CITY OF MADISON

SHAWNEE PASS ASSESSMENT DISTRICT 2025, NAKOMA SIDEWALK, AND NAKOMA CULVERT

CITY PROJECT NO. 11822
CONTRACT NO. 8783

ADDENDUM #1 - 4/8/25
REVISED THE FOLLOWING:
D-3, D-5, P-5, U-5, U-7

11822
D-3

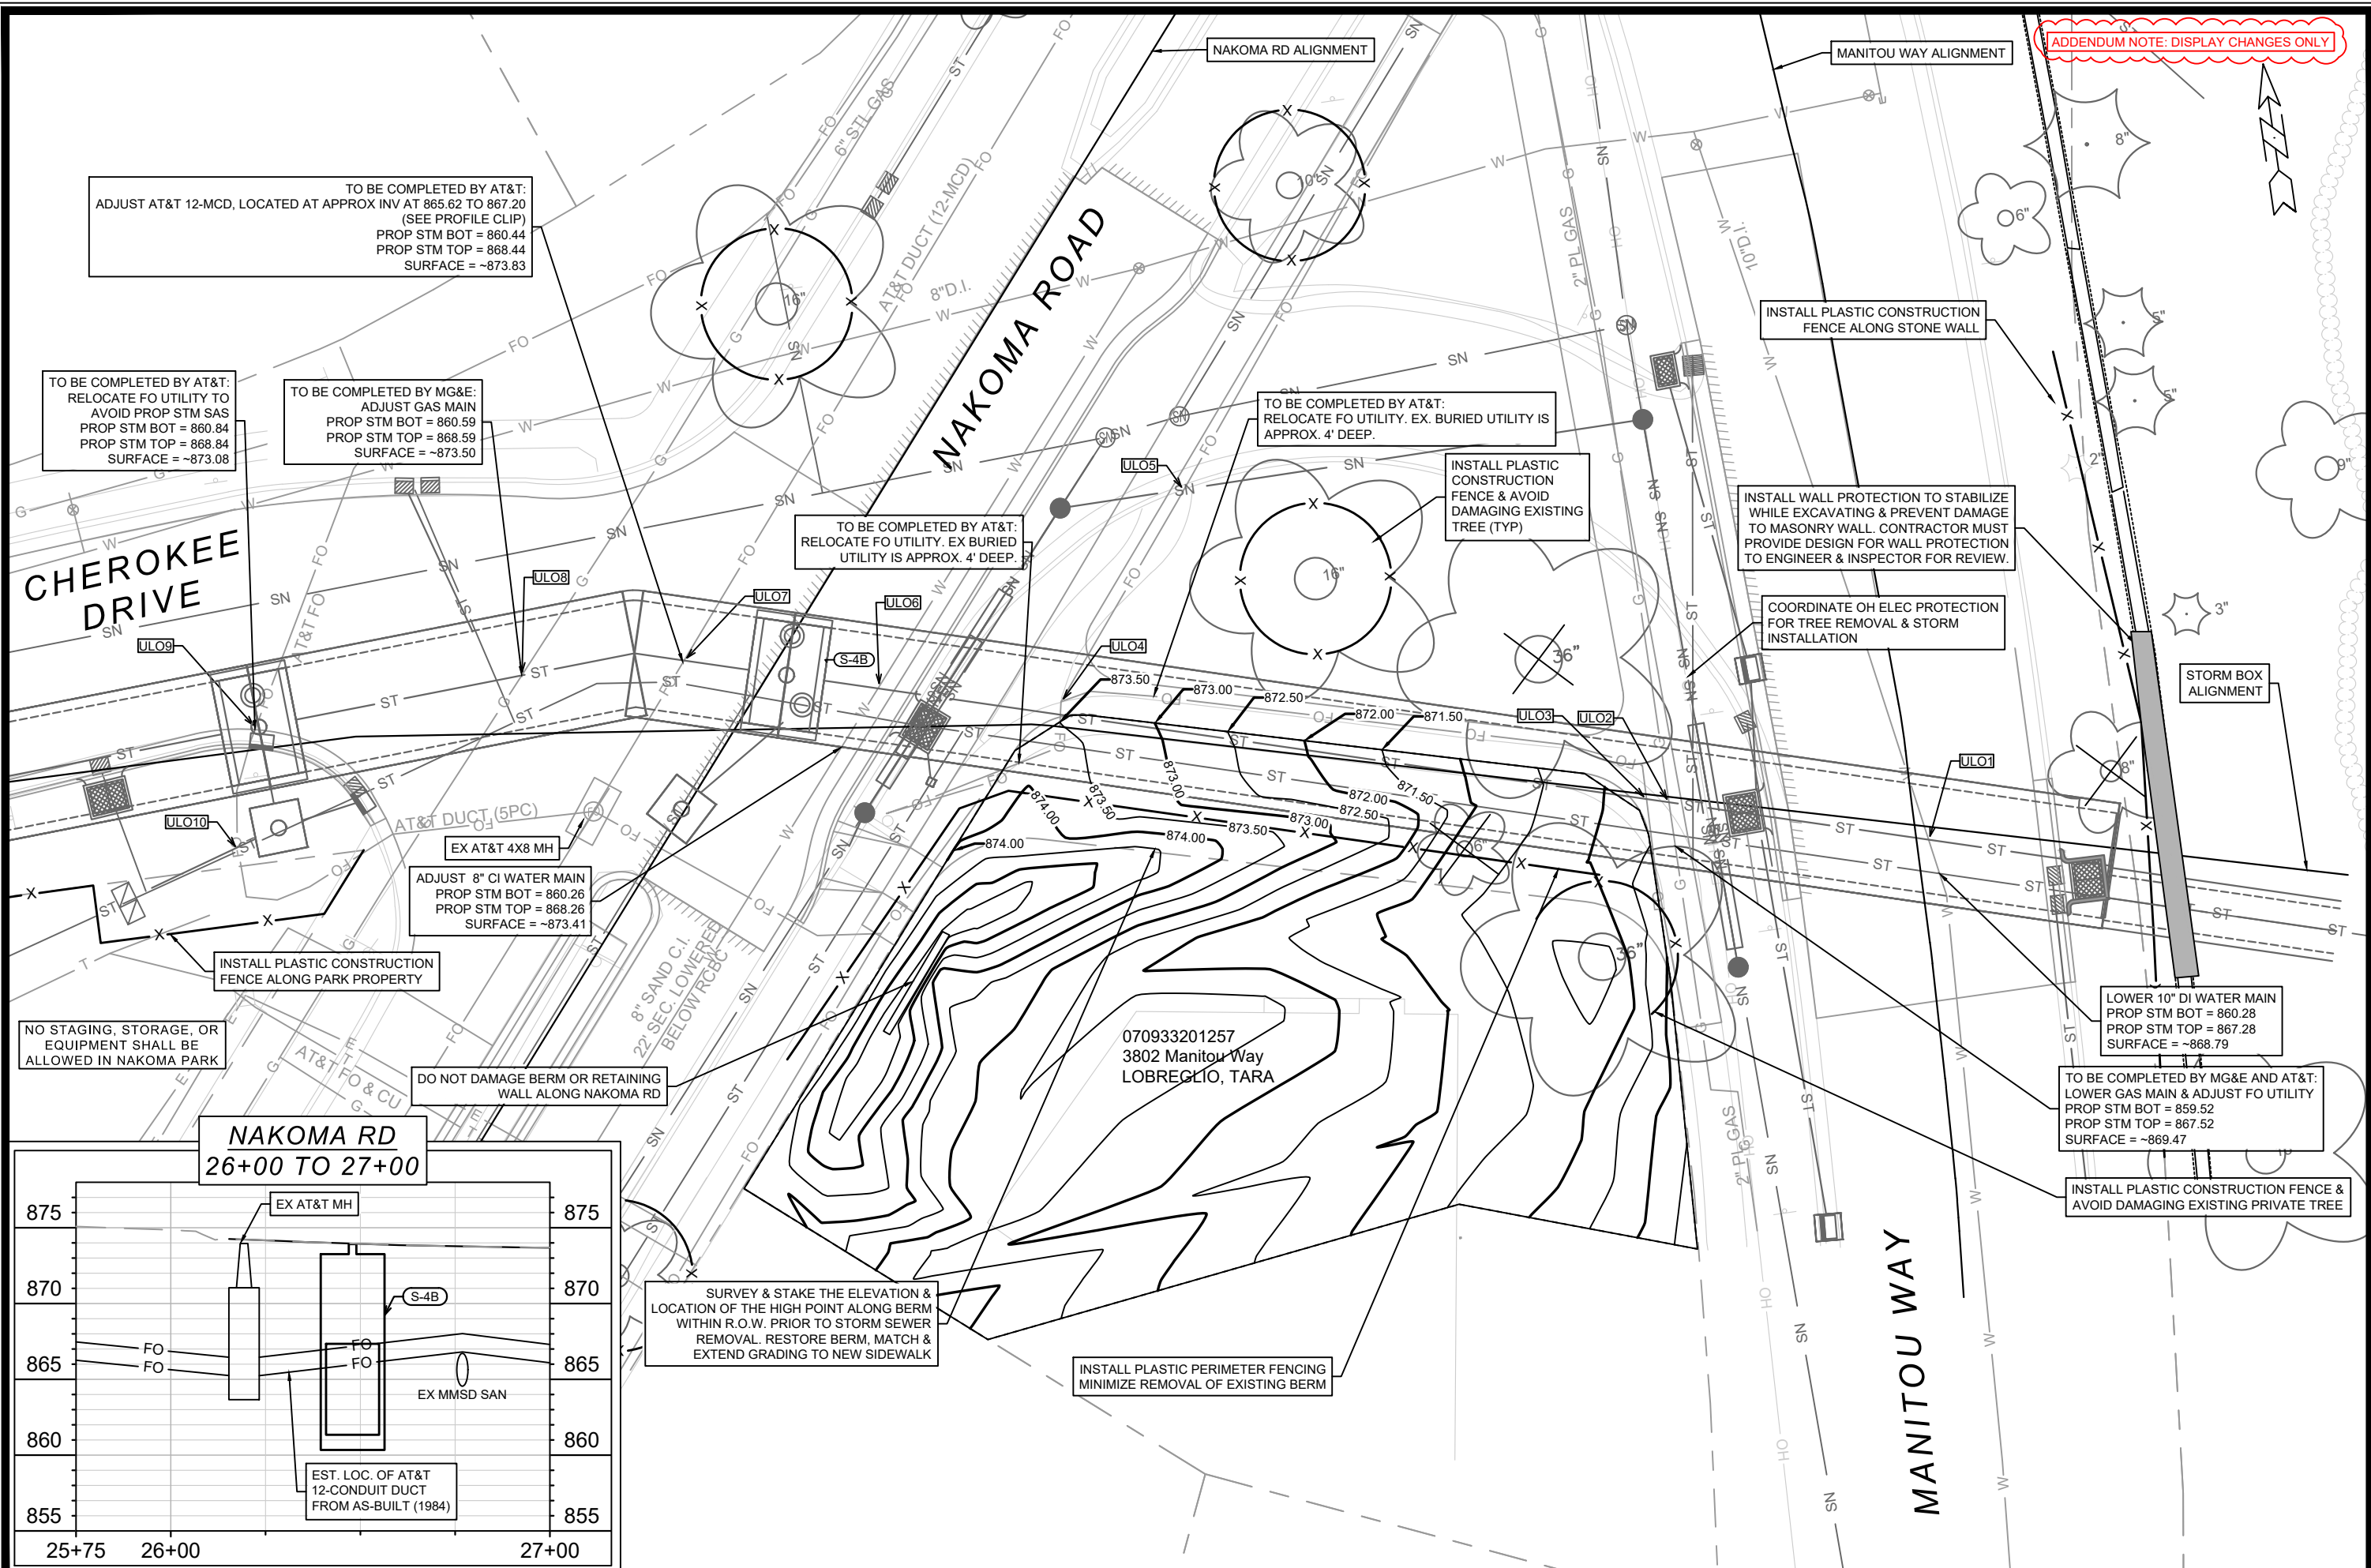
ADDENDUM NOTE: DISPLAY CHANGES ONLY

D-5

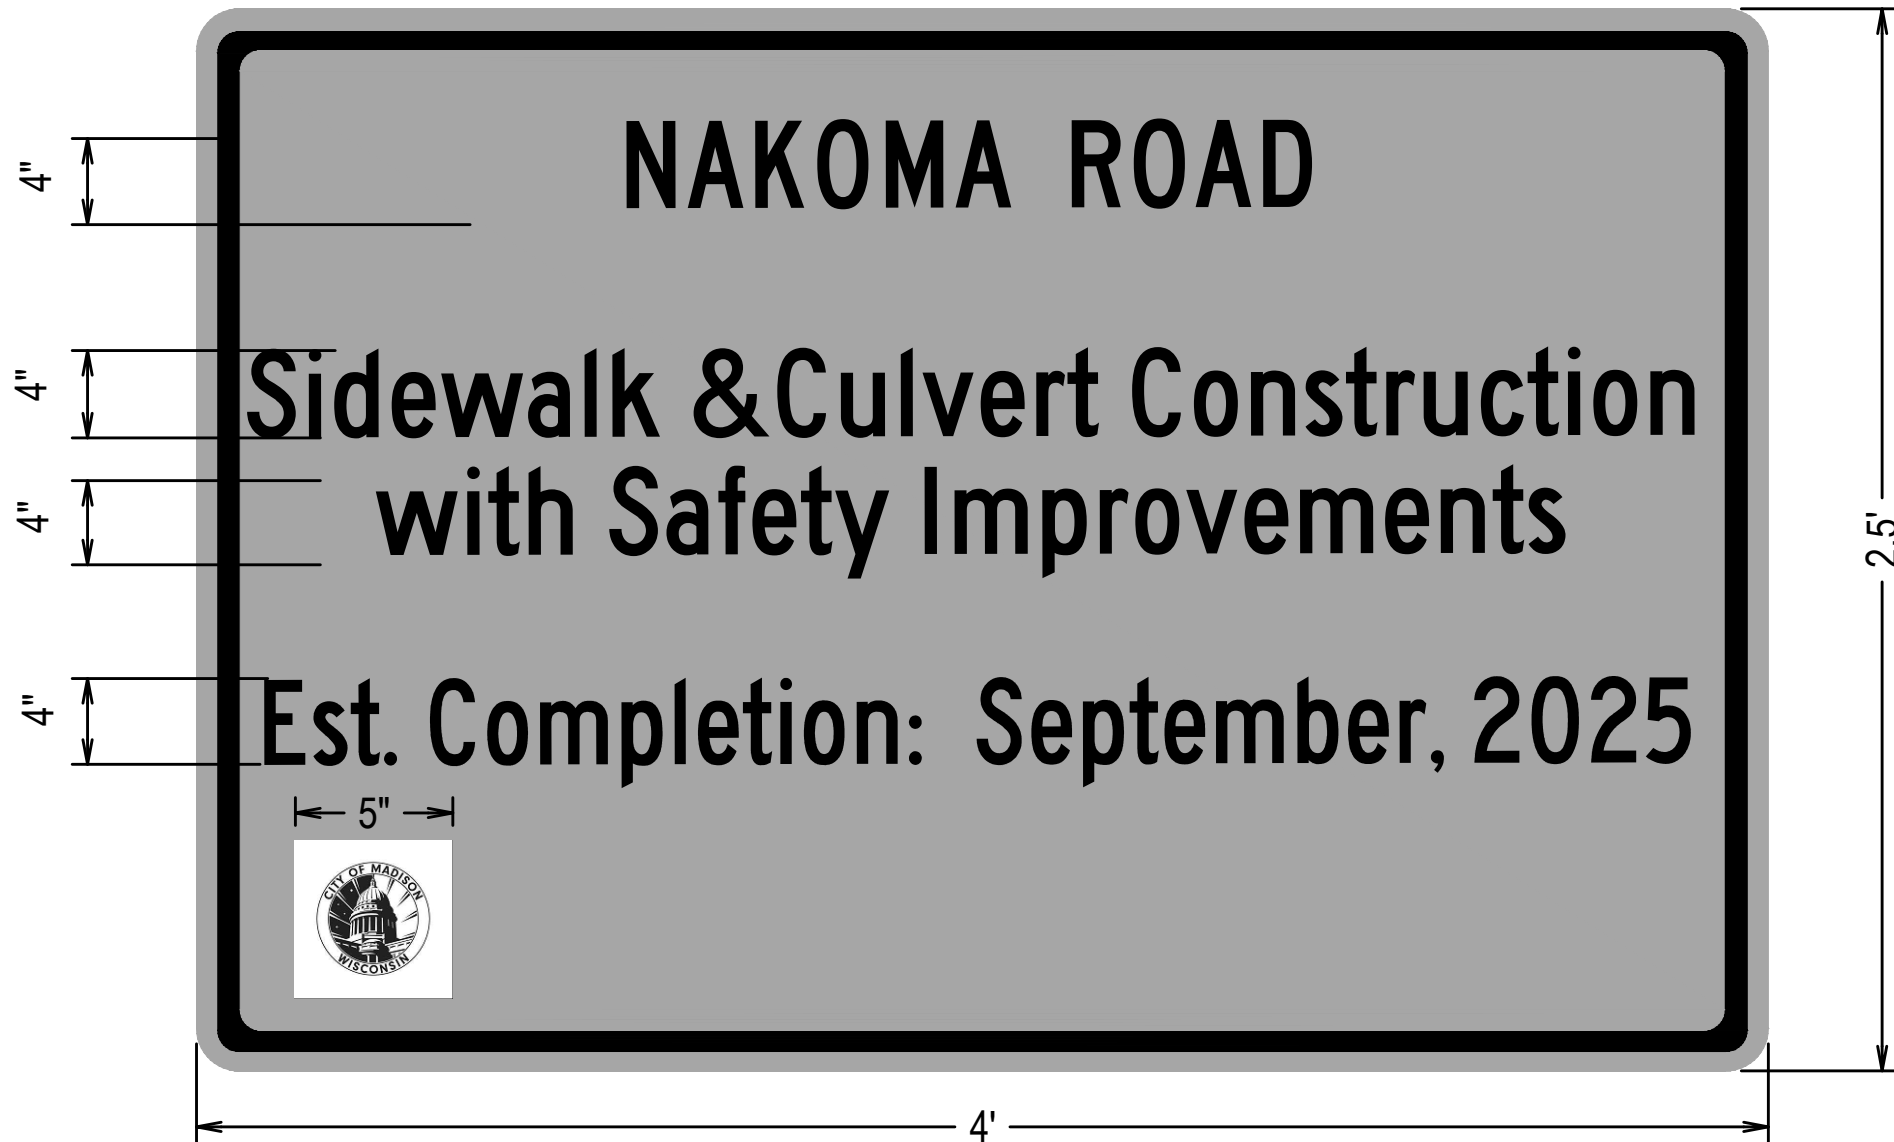
ADDENDUM 1: MFG 4/8/25
CHANGED AUGUST ESTIMATED COMPLETION TO
SEPTEMBER

11822		MADISON, WI		CONTRACT NO: 8783	
NAKOMA ROAD PLAN		SHAWNEE PASS, NAKOMA SIDEWALK, AND NAKOMA CULVERT		P-5	
CITY OF MADISON WISCONSIN		M:\DESIGN\Projects\11822\CAD\Streets\11822EN-PnP.dwg		11822	
11822		P-5		P-5

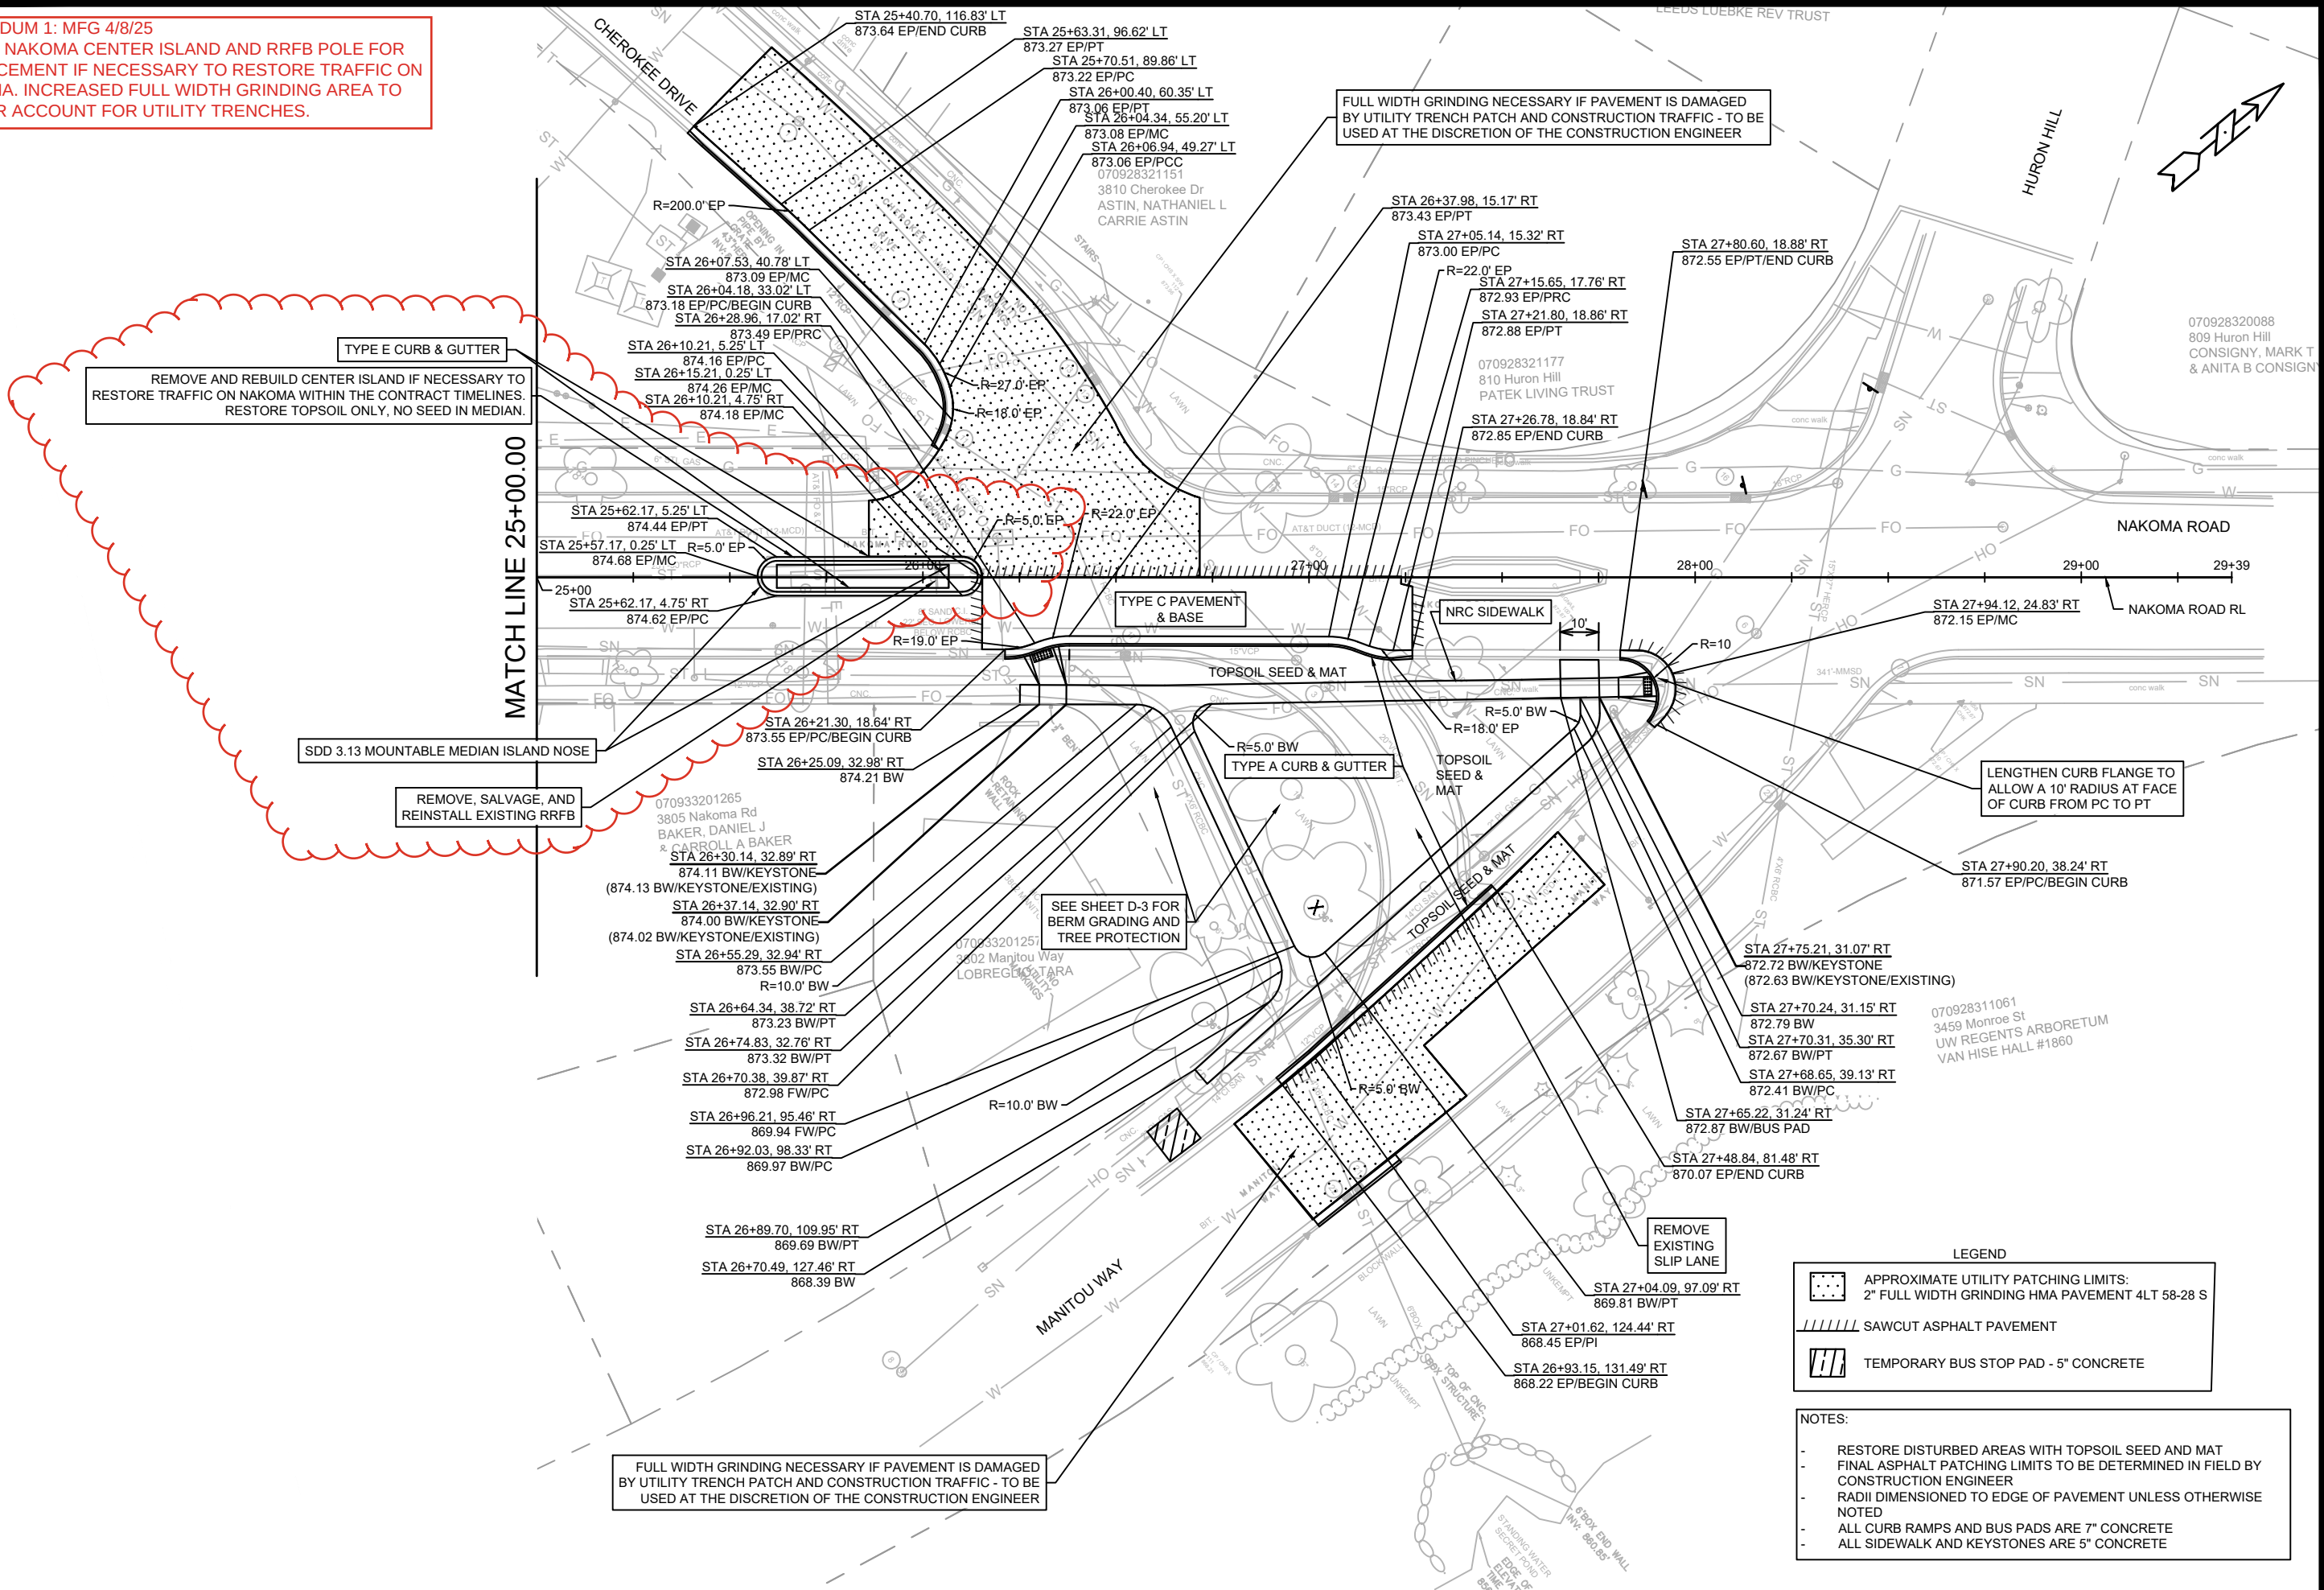
ADDENDUM 1: MFG 4/8/25
ADDED NAKOMA CENTER ISLAND AND RRFB POLE FOR
REPLACEMENT IF NECESSARY TO RESTORE TRAFFIC ON
NAKOMA. INCREASED FULL WIDTH GRINDING AREA TO
BETTER ACCOUNT FOR UTILITY TRENCHES.

NAKOMA SIDEWALK PROJECT NO. 11822	SHEET NO. U-7
STORM SEWER SCHEDULE	
MANITOU WAY STORM BOX REPLACEMENT	CITY OF MADISON

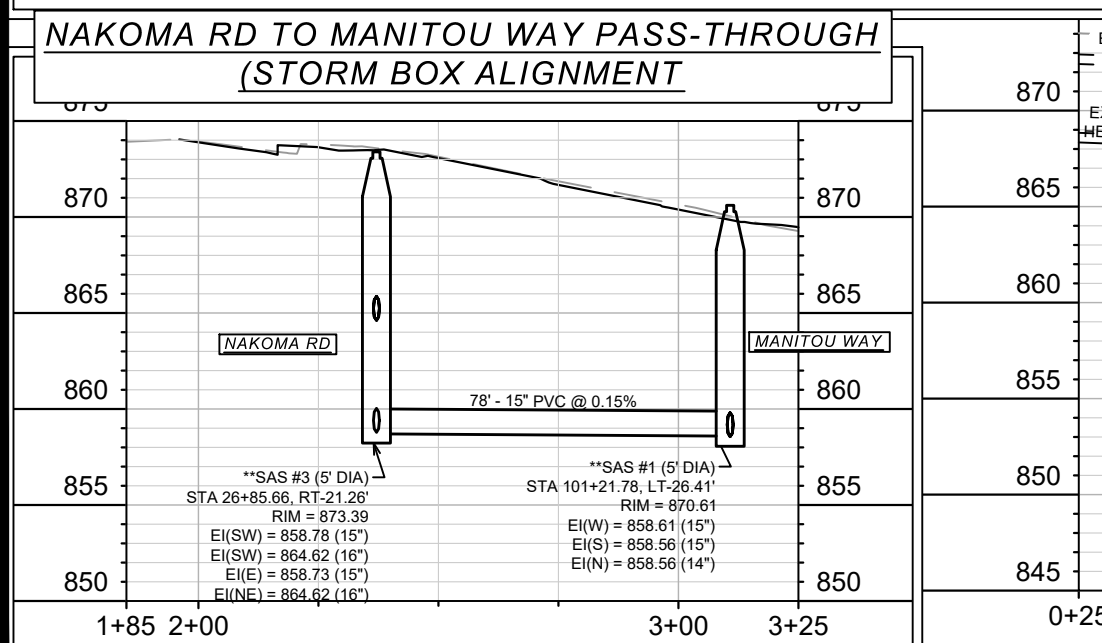
+ ADDENDUM 1 - 4/8/2025 DAO
